MONTGOMERY COUNTY PLANNING DEPARTMENT

MEMORANDUM

SUBJECT: Mandatory Referral No. 10719-DGS-1: Silver Spring Library
900 Wayne Avenue, CBD-1 Zone, Silver Spring CBD Sector Plan

RECOMMENDATION: APPROVAL and transmit the following comments:

Site Plan

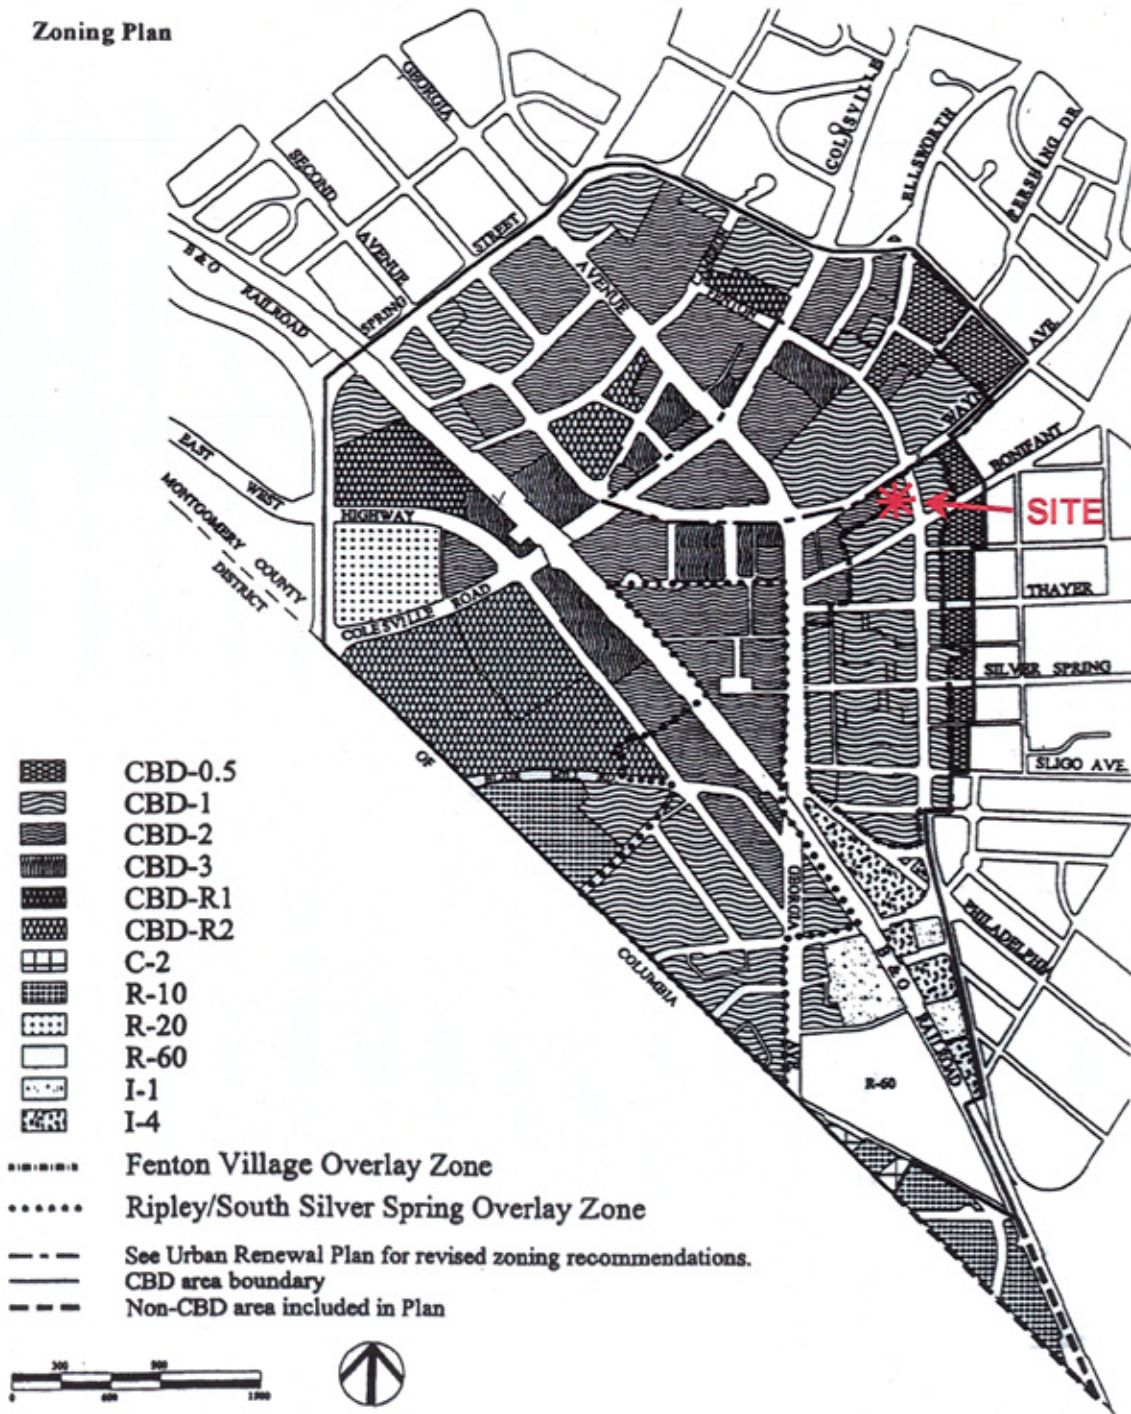
1. Submit a Preliminary Plan with dedications for Wayne Avenue and Fenton Street and a dedication or easement for the Purple Line, and with the location of the roof overhang inside the property

2. Provide conformance with the Silver Spring Streetscape Standards as follows:
 - a. Reduce the tree spacing to 30 feet o.c.
 - b. Obtain approval from Urban District for non-conforming sidewalk paving

As the library is presently designed, the roof overhang intrudes on the right-of-way of Fenton Street and Wayne Avenue. The roof overhang should be located outside the right-of-way in accordance with the requirements of the MCDOT.

Circulation Plan

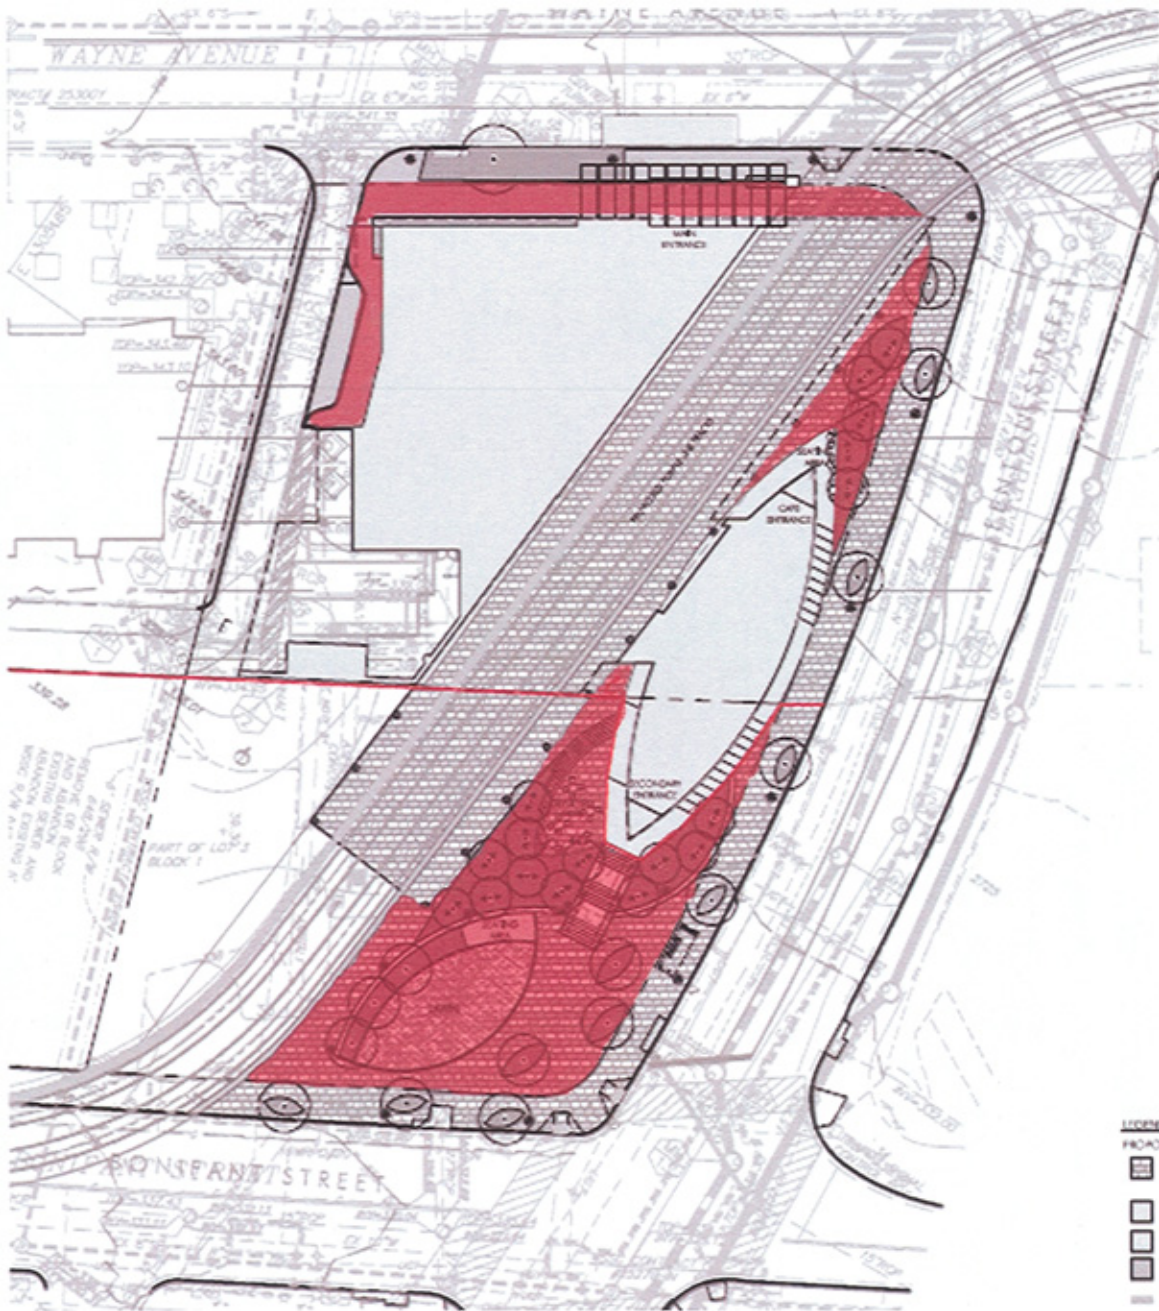
7. Consider locating a drop-off area along Fenton Street
8. Ensure that the proposed coffee bar does not significantly compete with businesses in the Fenton Village District

Vehicle Access - A vehicular drop-off and service area are located at the rear of the building adjacent to the Crescent Building. Staff recommends that the applicant consider adding a drop-off area on Fenton Street in front of the proposed library to allow at least two cars to drop-off books along Fenton Street. This will give patrons another drop-off area and reduce conflicts with the service area.
